JRPP PLANNING REPORT

JRPP NO:	2012SYW030
DA NO:	870/2012/JP
PROPOSED DEVELOPMENT:	APARTMENT BUILDING AND TOWN HOUSE DEVELOPMENT
SUBJECT SITE:	LOT 6 DP 1085297 - 40-52 BARINA DOWNS ROAD, BAULKHAM HILLS
APPLICANT:	MERFAD PTY LIMITED
LODGEMENT DATE:	16 FEBRUARY 2012
REPORT BY:	DEVELOPMENT ASSESSMENT CO-ORDINATOR GAVIN CHERRY
RECOMMENDATION:	REFUSAL

Building C

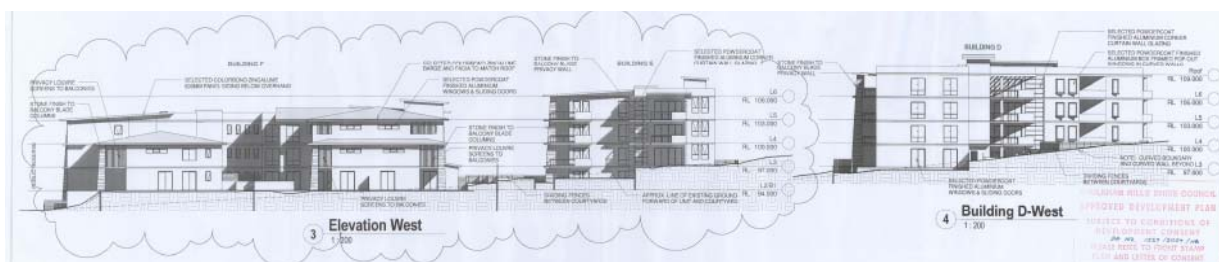
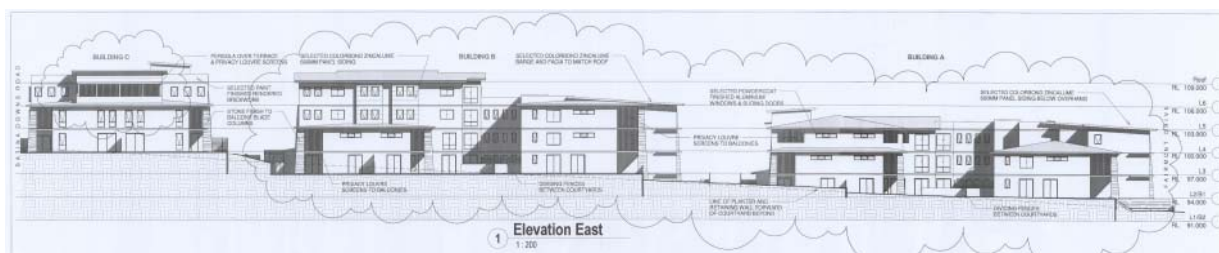
As detailed above, the building heights as approved substantially represented two to three storeys above the natural ground level at the property boundaries. While some locations represented a part four storey component, the development was smaller in bulk and scale to that currently proposed and below the maximum eave and ridge height envelope requirements within the DCP. Furthermore as the future redevelopment of the adjoining sites would be to a maximum two storey height limit for future multi unit housing, an apartment building development similar to that already approved would provide a visual one storey transition from town houses, to apartments and then back to town houses. In this regard the proposed development and additional storey provision is not considered to comply with the first objective detailed above or the standards within the DCP.

The information submitted from the applicant has satisfactorily demonstrated that the streetscape presentation to Barina Downs Road will provide a suitable transition between the front smaller apartment buildings (Building C and D) to the adjacent dwelling houses either side. This smaller built form provides the transition recommended to be incorporated across the entire site (similar to what was previously approved). While the submitted cross site elevations have attempted to demonstrate a one to two storey transition at various selected locations (as per the map reference key on DA16), these section drawings do not adequately represent the resulting bulk and scale presentation to Fairmont Avenue or the visual presentation of Buildings A, B, E and F to the northern and southern adjoining properties. The resulting bulk and scale as viewed from these properties is most evident as reflected within Elevation 4 (Block E and F) and Elevation F (Block E and F). Refer to Attachment 5 for these elevations. Specific attention is drawn to the visual presentation of Blocks C and D as reflected within this drawing, which portrays a more reasonable integration between the intended built form on the subject site and the existing built form either side on adjoining allotments which was the reasoning behind the approval of the preceding application.

While a minor variation to the eave and height controls in the DCP, may be supportable for a typical apartment building development, the subject site is not a typical R4 zoned allotment and as such greater emphasis on the number of storeys and the visual bulk and scale of the proposal is considered to take precedent over the numerical DCP requirements and indicated plane discrepancies.

In this regard the likely future redevelopment of surrounding properties further reinforces the appropriateness of the existing approved development and the inappropriateness of the proposed new development and increased building heights as outlined within this section and Section 4.1 of this report. It is recommend that the development be amended to remove the additional building height proposed for Buildings A, B, E and F and retain the built form transitions previously approved within the Development Consent 1557/2007/HB.

ATTACHMENT 6 – SECTION DRAWINGS

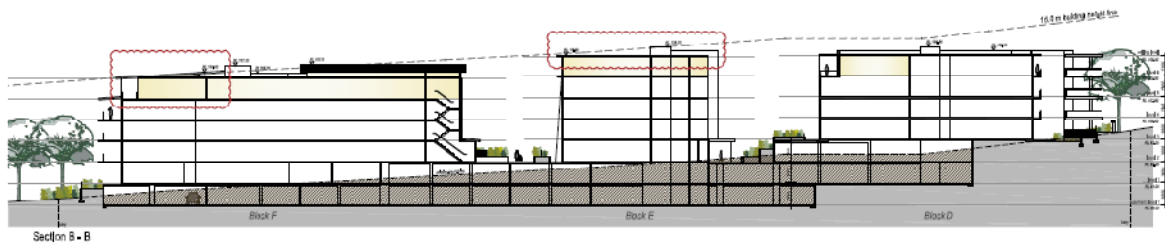
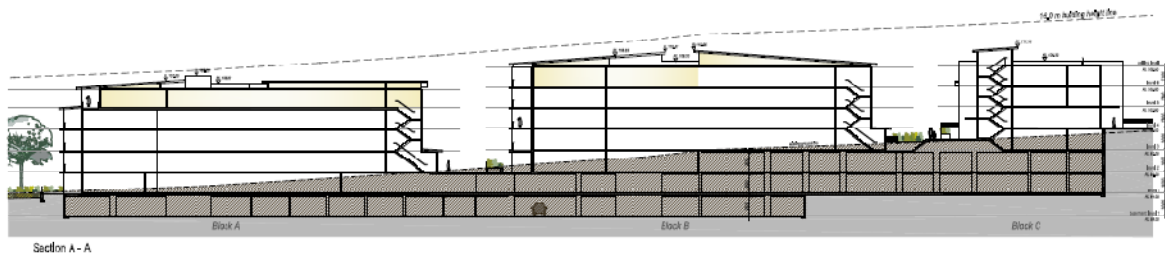
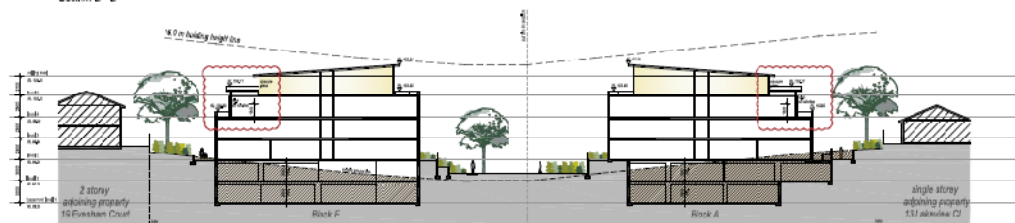
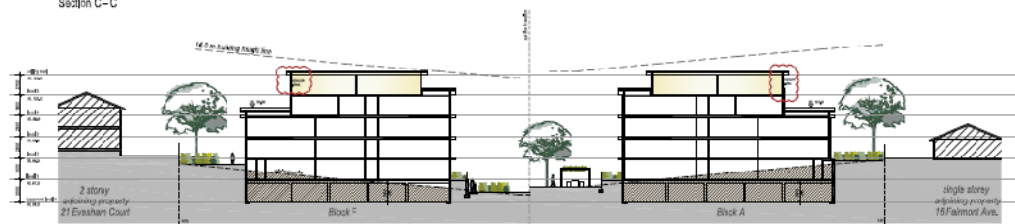
As detailed within Section 4 of this report, the indicated building height planes on the submitted elevation drawings do not appear to accurately represent the required 16.0m height plane. The applicant has provided written advice reiterating that the development complies with the DCP and Draft LEP height requirements with indicated breaches resulting from drawing constraints. As such the applicant has advised that reliance on the elevation drawings submitted does not provide an accurate representation of the maximum building heights proposed. Further assessment of the plans however has still

identified discrepancies in the height planes indicated on the submitted elevation drawings of up to 17.2m above natural ground level. In addition the submitted section drawings indicate a maximum building height of 16.8m associated with roof top plant and 16.3m associated with roofing elements as shown on Section Drawing B-B within Attachment 6. In this regard the development is not considered to comply with the maximum 16.0m height requirement.

3.4 Building Heights (per storey)	13 metres to eaves 16 metres to ridge	<p>Maximum eave height of 13.4m associated with Building F as indicated on Section B-B.</p> <p>Maximum ridge height of 16.8m associated with roof top plant of Building F (maximum roof level of 16.3m) as indicated on Section B-B.</p>	<p>No - The applicant has submitted detailed justification to state that the proposed building heights comply with the 16.0m height requirement however reassessment of the section drawings submitted has still identified maximum eave and ridge height variations.</p>
